Review of DOE Planned Change Request for Shielded Containers for Remote-Handled Transuranic Waste

**Contract Number EP-D-10-042
Work Assignment No. 1-02
Revision 4**

December 29, 2010

Figure 5-1: Mean DBRs from SCPA Scenarios 2 and 3 and PABC-2004, Replicate 1
(Dunagan et al. 2007)

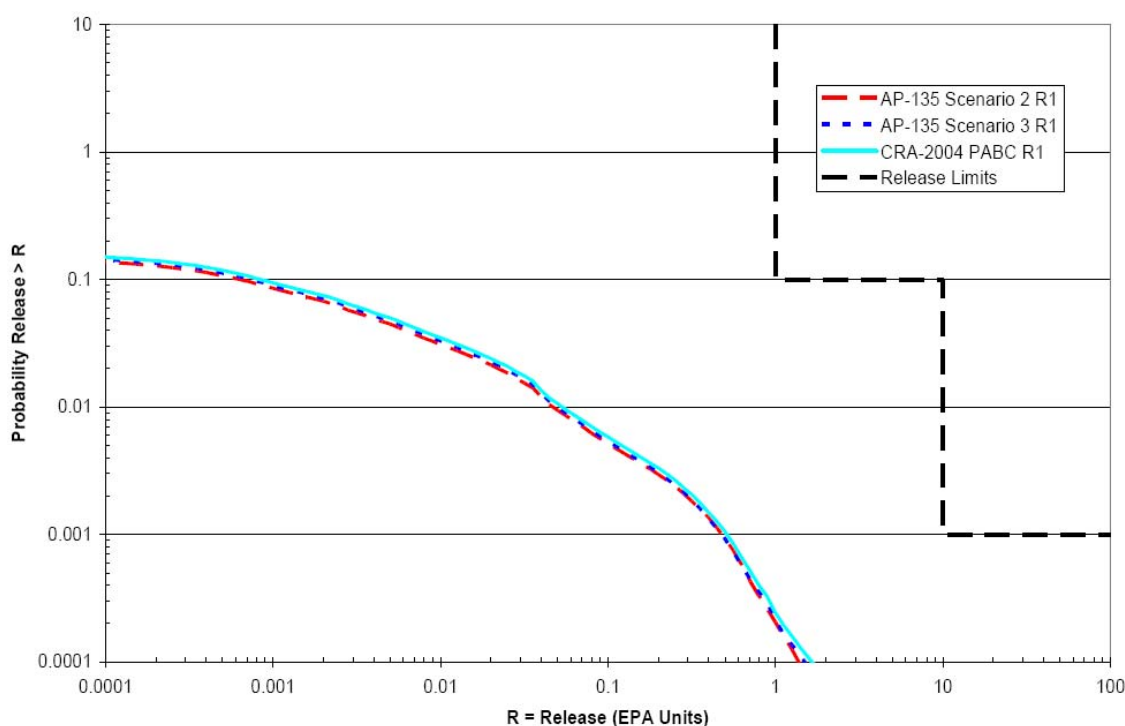
DOE indicates that the mean DBR CCDFs have no significant differences between SCPA scenarios and the PABC-2004. Based upon Figure 5-1 (from Dunagan et al. 2007), this assertion also appears to be supported. However, as shown in that figure, the mean DBRs for SCPA Scenario 2 are consistently the smallest, and the mean DBRs for the PABC-2004 are consistently the largest, but the differences are minor.

DOE also indicates that even though the PABC-2004 had the largest mean DBRs at all probabilities, the difference between the DBRs for the PABC-2004 and the SCPA scenarios was still extremely small and not large enough to discernibly impact mean total releases.

DOE satisfactorily explains the differences between the various scenarios, and their assertion that the differences are small is supported by the results presented in Figure 5-1.

Figure 5-2: Mean Total Releases from SCPA Scenario 2 and Scenario 4, Replicate 1
(Dunagan et al. 2007)

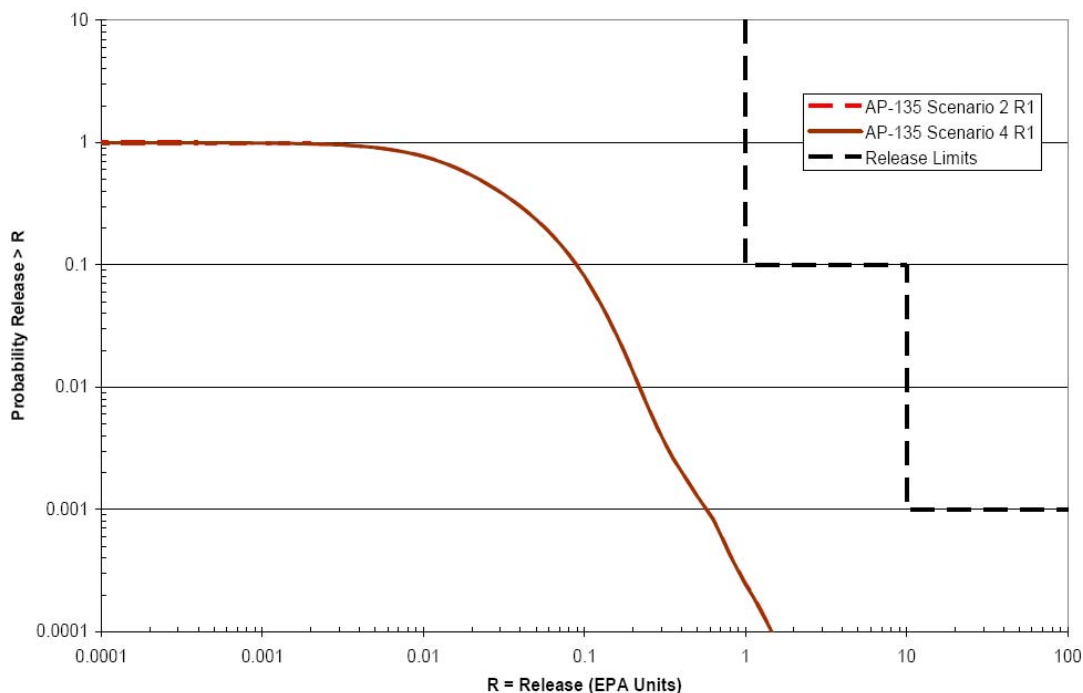
The total normalized releases for SCPA Scenarios 2 and 4, Replicate 1, are compared in Figure 5-2. DOE concludes that modeling the use of shielded containers with explicit representation of all 77 individual RH waste streams caused no differences of practical significance on the mean releases.

DOE's conclusion is supported by the results presented in Figure 5-2, in which the mean total releases for each of the scenarios are virtually indistinguishable from one another.

Figure 7-2: RH TRU Waste Stream At or Below the Limiting Cs-137 Concentration

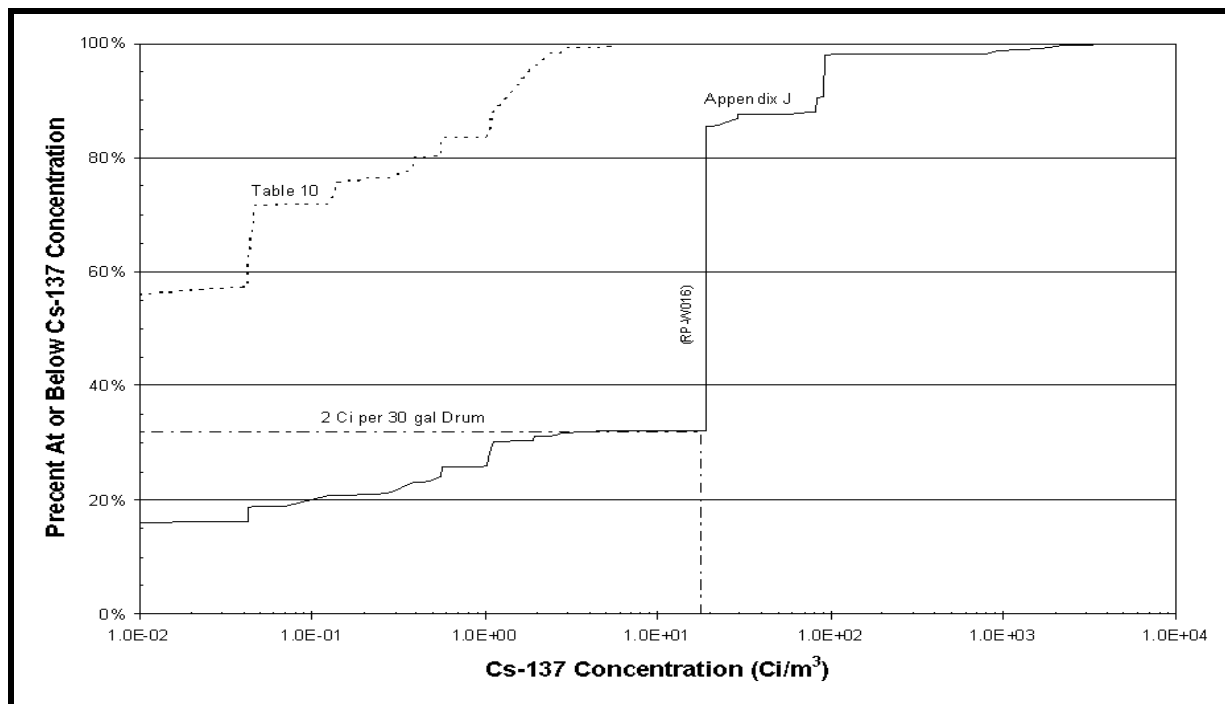
Although the average Cs-137 RH TRU waste concentration would exceed the surface dose rate limit if it were used to fill a 30-gallon drum, because the actual Cs-137 RH TRU waste concentration is expected to range from 1.6×10^{-6} to 7.530 Ci/m^3 , some volume of RH TRU waste containing Cs-137 would be suitable for shielded container disposal. In fact, Figure 7-2 shows that about 32% of the final RH TRU waste form volume could be packaged in shielded containers, assuming that Cs-137 is the dominant photon emitter. Figure 7-2 is based on the individual RH TRU waste stream Cs-137 concentrations given in DOE 2006b, Appendix J, and a total RH TRU disposal volume of $7,080 \text{ m}^3$. Figure 7-2 shows two curves; the solid line curve is based on the Cs-137 concentrations for all of the RH TRU waste streams presented in DOE 2006c, Appendix J, while the dotted curve is based on only those RH TRU waste streams listed in Crawford and Taggart 2007, Table 10. Table 10 of Crawford and Taggart (2007) lists only those waste streams that would meet the 2-Ci limit for Cs-137. The large “step” in the middle of the DOE 2006c Appendix J curve is due to a single waste stream, RP-W016 “PUREX TRU

Cladding Removal Solids,” which has a final form volume of 3,943.6 m³ and a Cs-137 concentration of 19.1 Ci/m³.⁸

Of course, the LANL analysis (Crawford and Taggart 2007) and this critique are for planning purposes only, and the final determination as to which RH TRU waste would actually be packaged in shielded containers would be made based upon the measured gamma and neutron dose rates.

Figure 7-3: Fraction of RH TRU Waste Streams At or Below the Limiting Cs-137 Concentration Based on 2008 Inventory

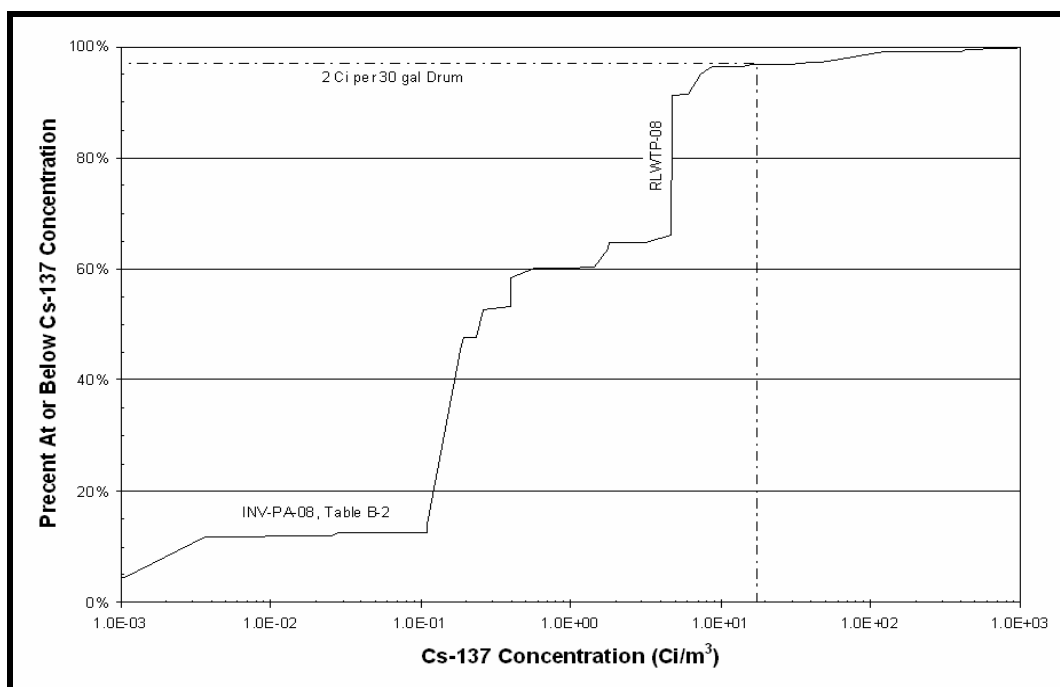
Similar to the PABC-2004 inventory (DOE 2006c), even though the average Cs-137 concentration based on the INV-PA-08 inventory is below what would be allowable in a shielded container, the individual RH TRU waste stream Cs-137 concentrations range from <0.001 to 3,140 Ci/m³ (INV-PA-08, Appendix B). Therefore, it is expected that the shielded container would not be usable for some fraction of the RH TRU waste. Figure 7-3 shows that about 97% of the final form waste volume from INV-PA-08, Appendix B, could be packaged in shielded containers, assuming Cs-137 is the limiting radionuclide.
